**ROCK HARBOR COMMERCIAL WHARF IMPROVEMENTS
TOWNS OF ORLEANS, MA
ADDENDUM #3**

PROJECT: Rock Harbor Commercial Wharf Improvements

DATE: March 22, 2024

CONSULTING ENGINEER: Foth Infrastructure & Environment, LLC
15 Creek Road, Marion, MA 02738

A
WATER SERVICE DETAIL THROUGH SHEETPILE
SCALE: 1" = 1"

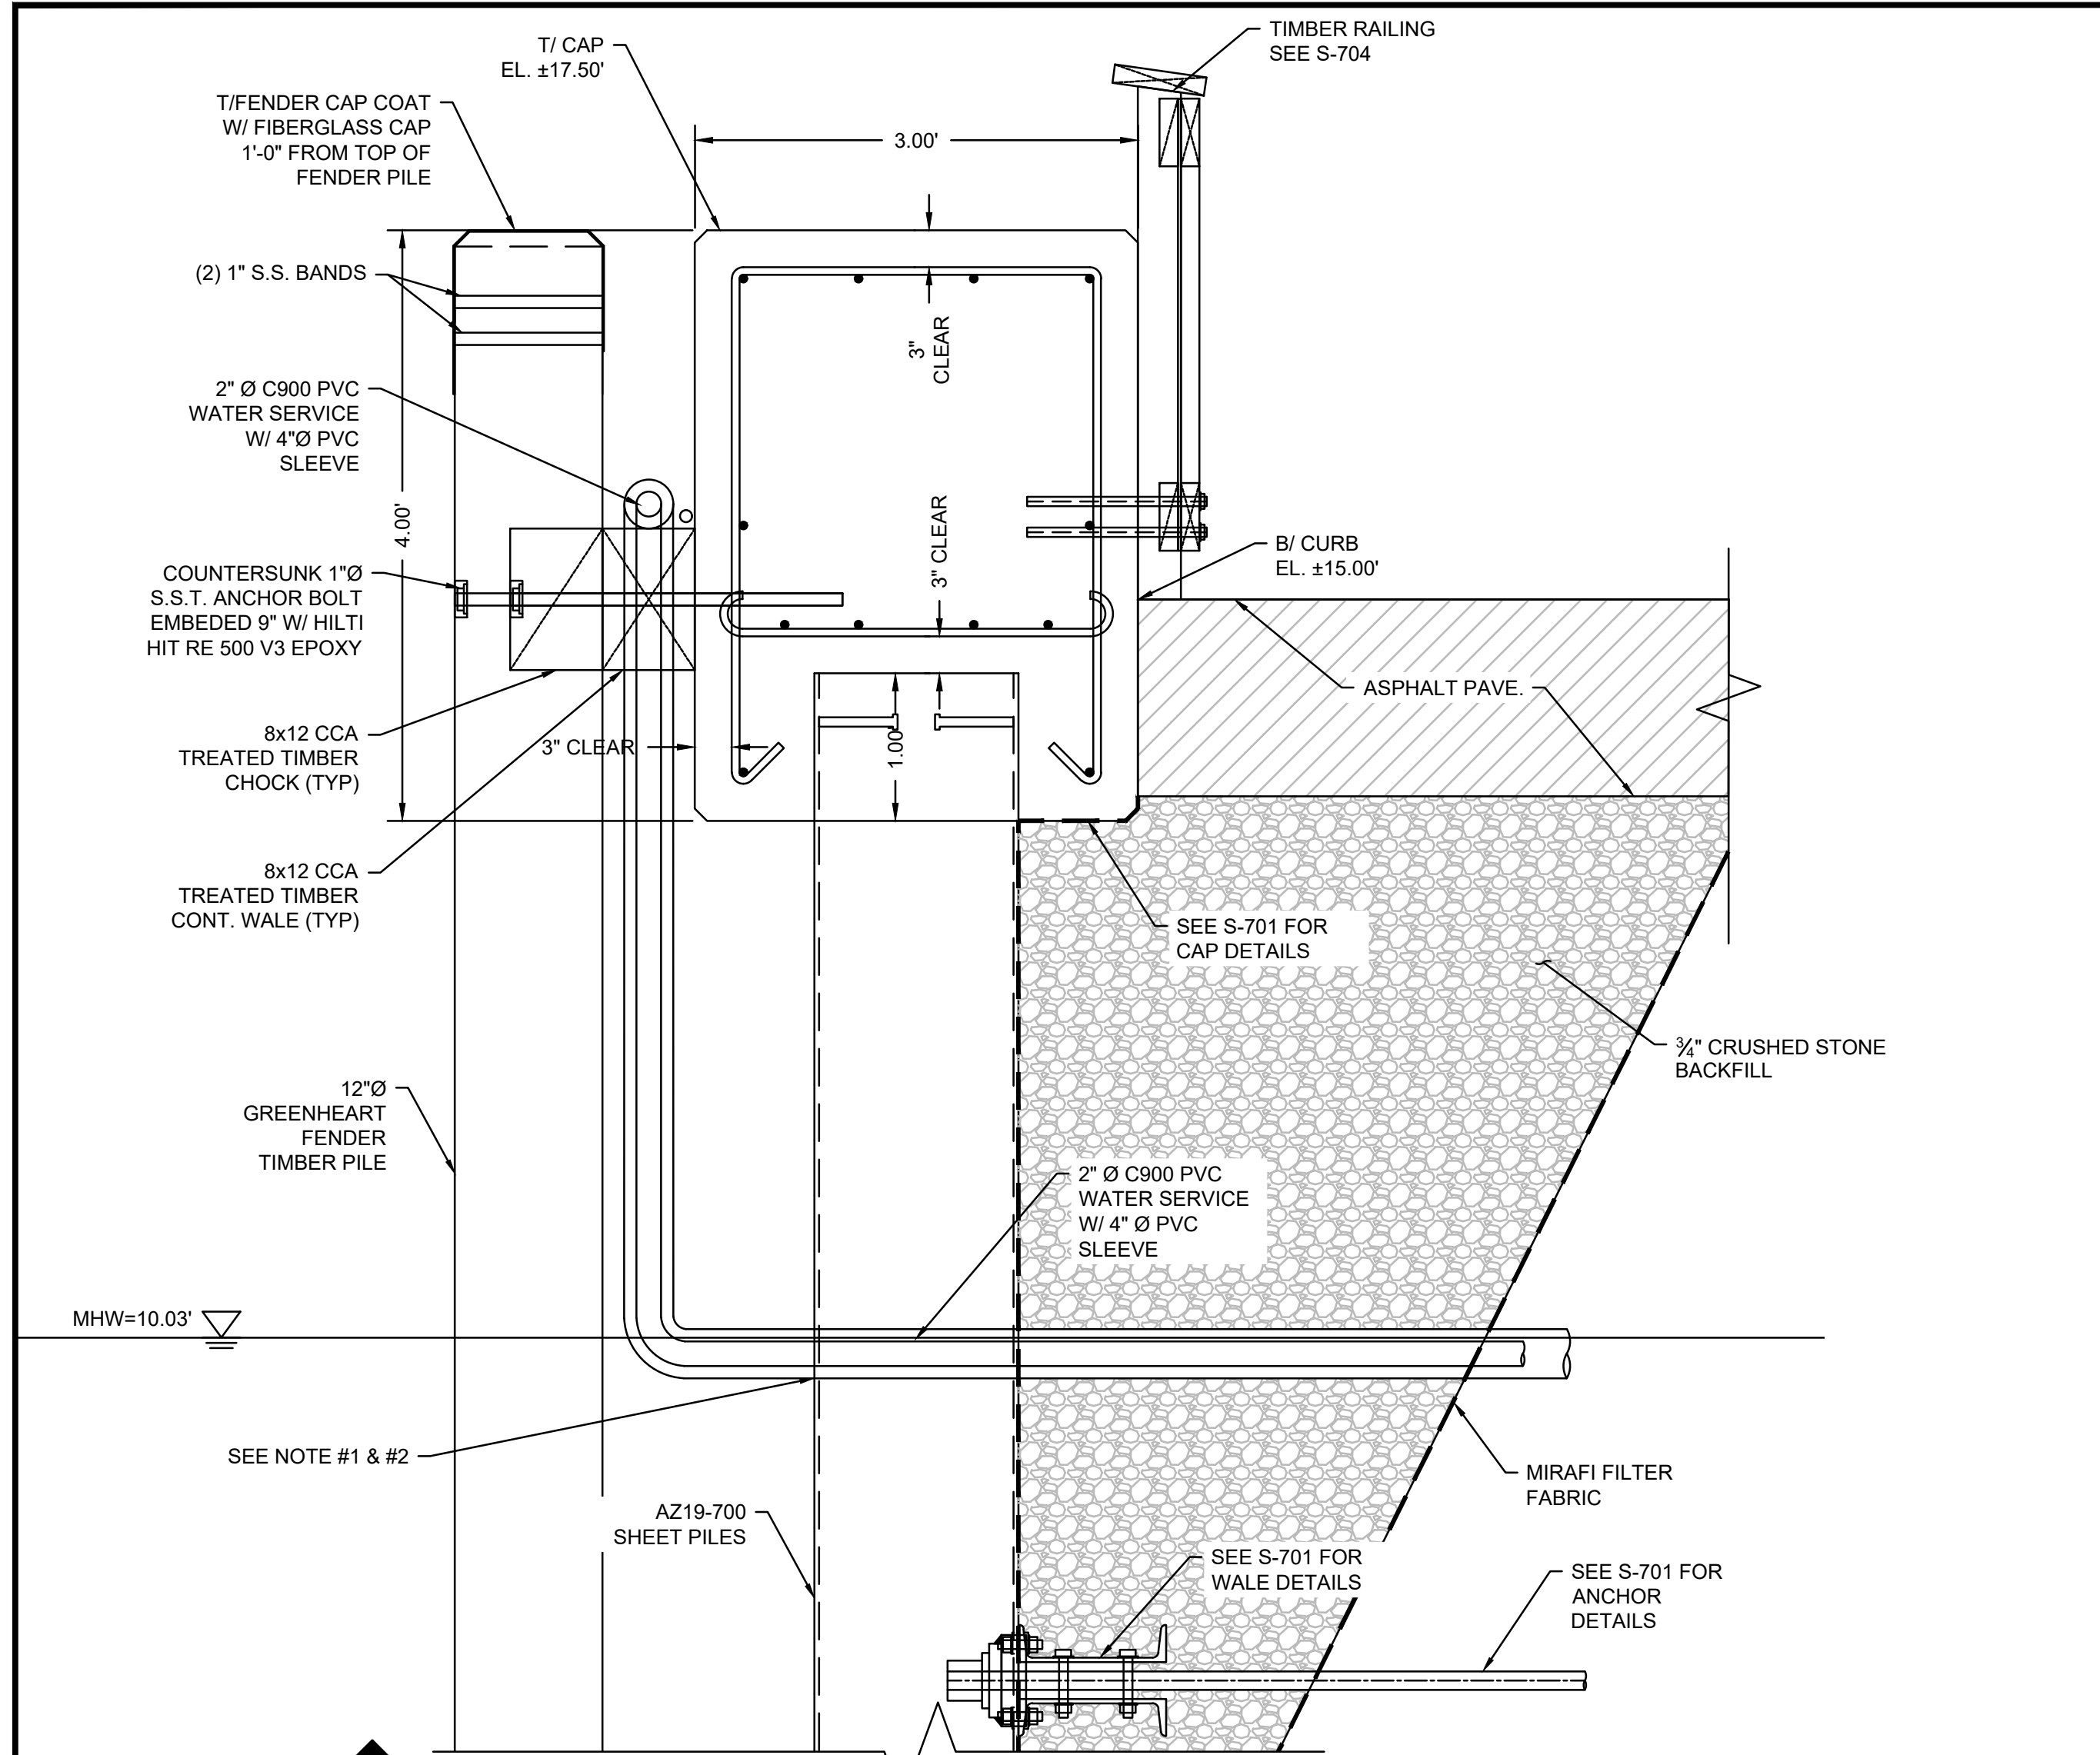
13. *Referring to drawing S-702, detail A shows the 2" C900 PVC water service with 4" PVC Sleeve on 8x12 CCA treated timber chock. Is the 2" C900 PVC water pipe or 4" PVC sleeve required insulated?*

RESPONSE: Neither the 2-inch C900 PVC water pipe or 4-inch PVC sleeve are required to be insulated.
